January 25, 1985
FVY 85-08

Subject: Installation of Vermont Yankee Containment High Range Radiation Monitors (NUREG-0737, Item II.F.1-3)

ATTACHMENT 1
TO
VYNPC TO USNRC LETTER
DATED JANUARY 25, 1985

<p>VERMONT YANKEE NUCLEAR POWER STATION FINAL SAFETY ANALYSIS REPORT</p>
<p>REACTOR BUILDING SECTION A-A FIGURE 12.2-7</p>

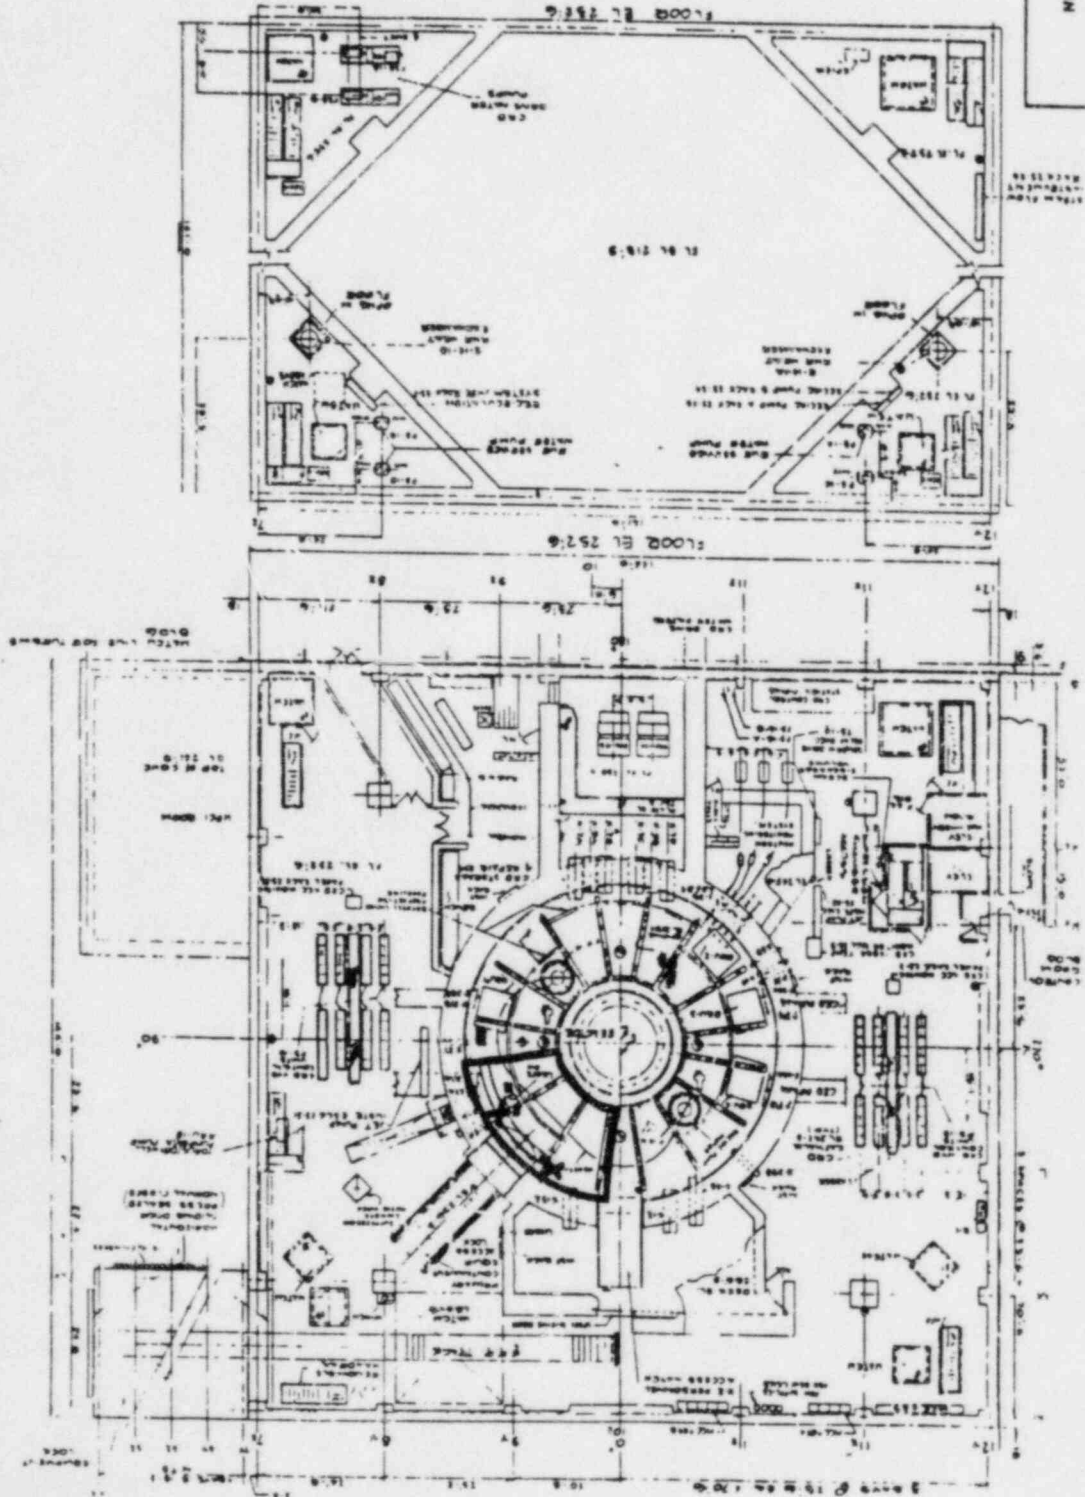
Therefore, Vermont Yankee concluded that the selected locations, as shown on the marked-up FSAR Figures 12.2-2 and 12.2-7, attached, are as widely separated as is reasonably achievable (Goal 2) without compromising other specified goals. Movement of the existing monitor locations would not provide any more accuracy than the existing locations, would tend to produce data with varying absolute values post-accident which would make assessment more difficult, and would result, unnecessarily, in additional operational radiation exposure to plant personnel associated with maintenance activities.

X - CONTAINMENT HIGH RANGE
MONITOR LOCATIONS
